Rezoning Transportation Analysis

Petition Number: #2022-109

General Location Identifier: 09709418

Date	Description
11-28-22	First Review (IW)
12-21-22	Second Review (IW)
01-25-23	Third Review (TM)
03-22-23	Forth Review (IW)
09-25-23	Fifth Review (IW)

~~Reference (CLDSM standard detail U-02) for residential medium street typical.~~

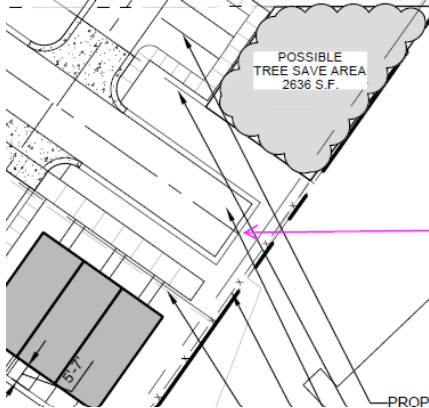
4. ~~The proposed dwelling units exceeds 12 per acre. Per Chapter 20 Subdivision ordinance, site plan and conditional note(s) revisions are needed to commit to construct an 8-foot planting strip, and 8-foot sidewalk along all public roads. The wider sidewalk also meets the Charlotte WALKS Policy.~~

~~**Outstanding Clarifying Comment 12-21-22:** Petitioner should add conditional note stating commitment of 8' planting strip and 8' sidewalk along both sides of all public roads. Reference (CLDSM standard detail U-02) for residential medium street typical section. Potential environmental conflicts to be coordinated during permitting if full section cannot be achieved.~~
